HOLDOVER

REVISED

VALLIMAR SUBDIVISION ADDITION

APPLICATION NUMBER 30 DATE March 20, 2003
APPLICANT Vallimar Subdivision Addition
REQUEST Subdivision

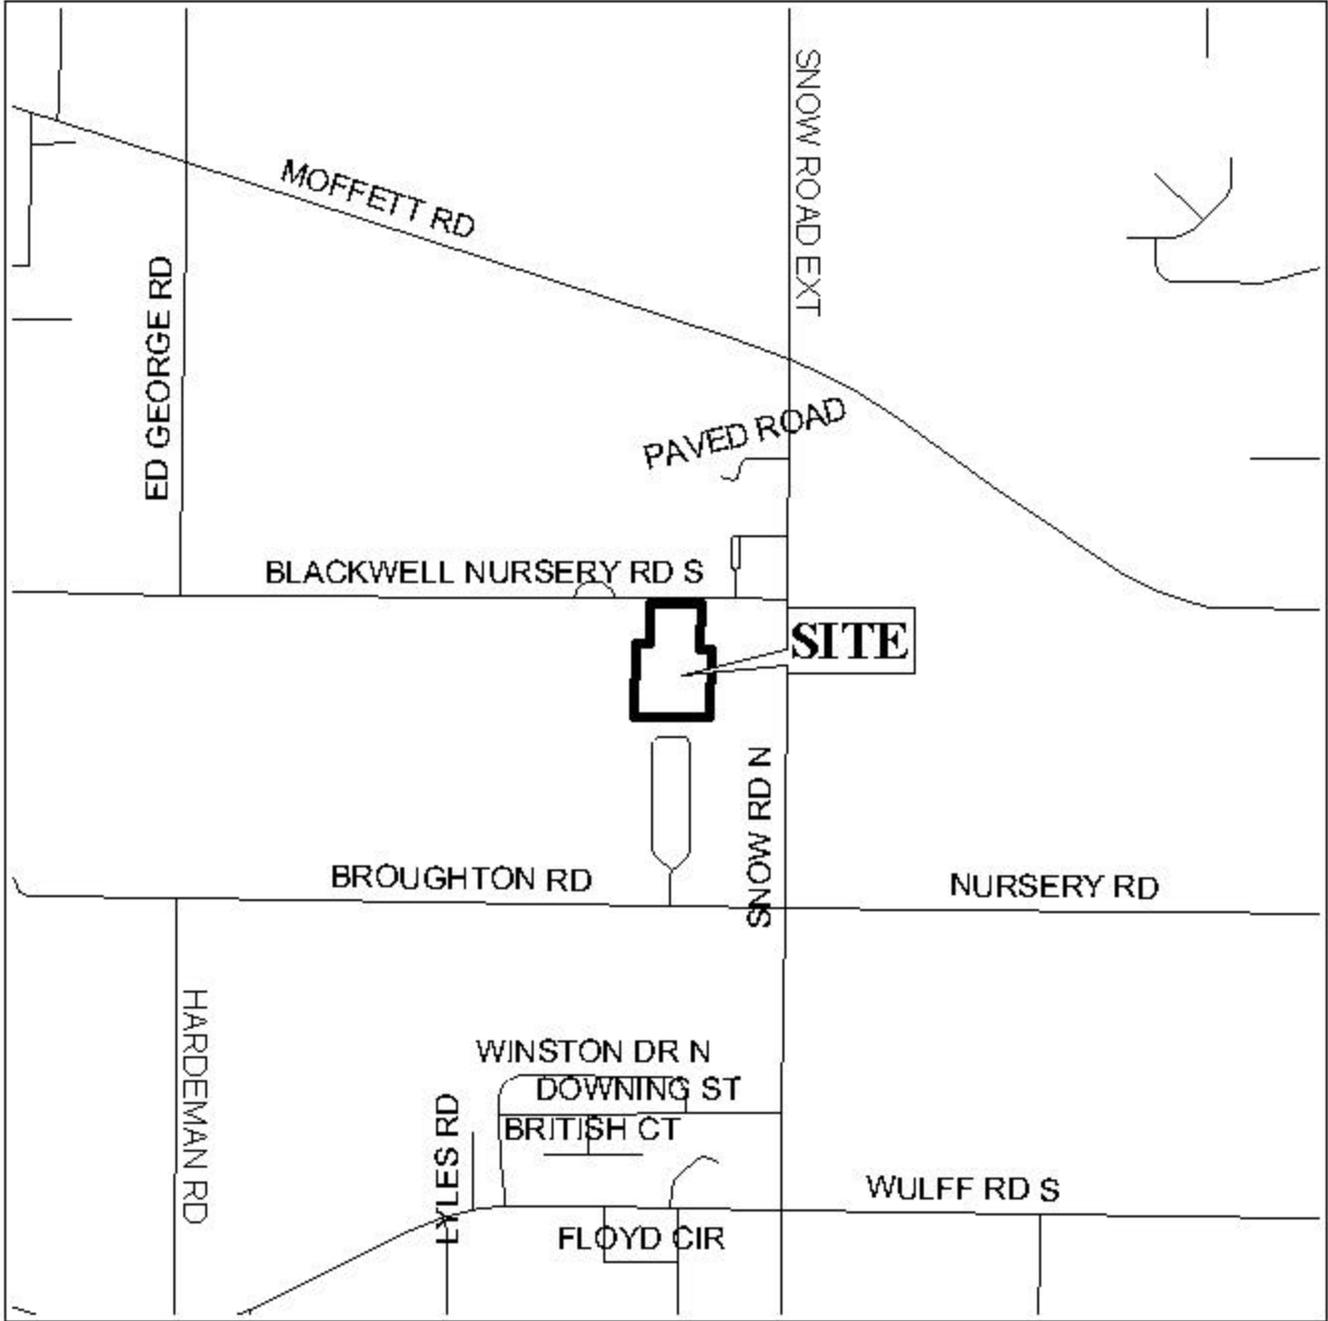
While the Commission has approved flag lot subdivisions in the past typically these subdivisions were in character with the surrounding area, this subdivision proposes six lots, four of which are flag-shaped. The commission has recently struggled with developing a policy regarding flag-shaped lots; however, the proposed plat has four flag-shaped lots. As illustrated on the Vicinity Maps there are no flag-shaped lots in the area.

Additionally, Section V.D.3 states that the depth of the lot not exceed 3.5 times the width. While the Commission sometimes waives this requirement the lots are typically fronting waterways and are approved with no more than two “flag” shaped lots. In this situation the “flags” are substantially larger than the minimum area requirements of the Subdivision Regulations and has the potential for resubdivision, especially Lot 1 which is approximately larger than five acres.

The application should be resubmitted showing a reconfiguration of the lots to be more agreeable to resubdivision in the future.

DETAIL SITE PLAN

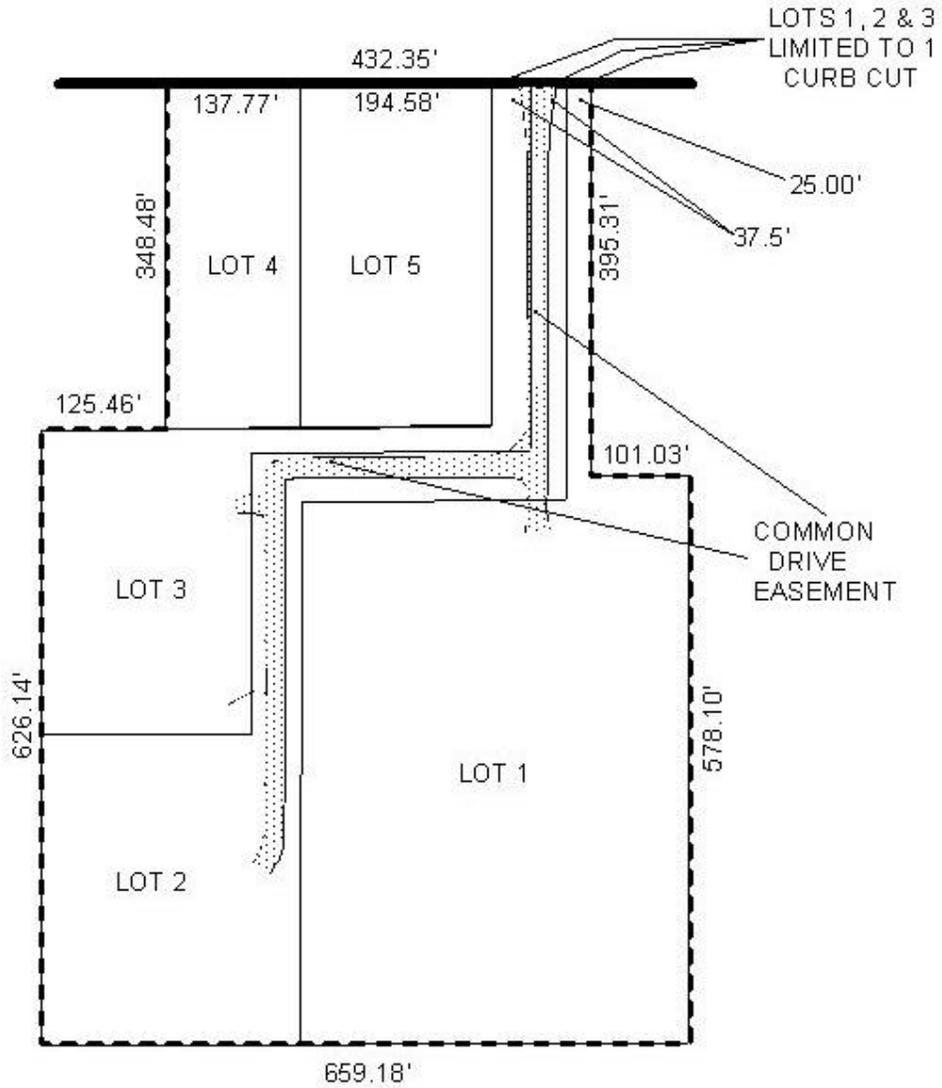
The applicant submitted a revised plat illustrating a 5-lot subdivision. Lots 2 and 3 of the revised plat each have 37.5-feet of road frontage, Lot 1 has 25-feet of road frontage along Blackwell Nursery Road.

The three “flag” shaped lots, contain substantially more area than the minimum requirements of the Subdivision Regulations, and thus there is potential for resubdivision; however, none of the lots have adequate street frontage for development of a street. Additionally, the “flags” are irregularly configured.

Based on the preceding this application is recommended for denial for the following reason: 1) Lots 1-3 do not comply with the width to depth ratio as required in Section V.D.3 of the Subdivision Regulations.
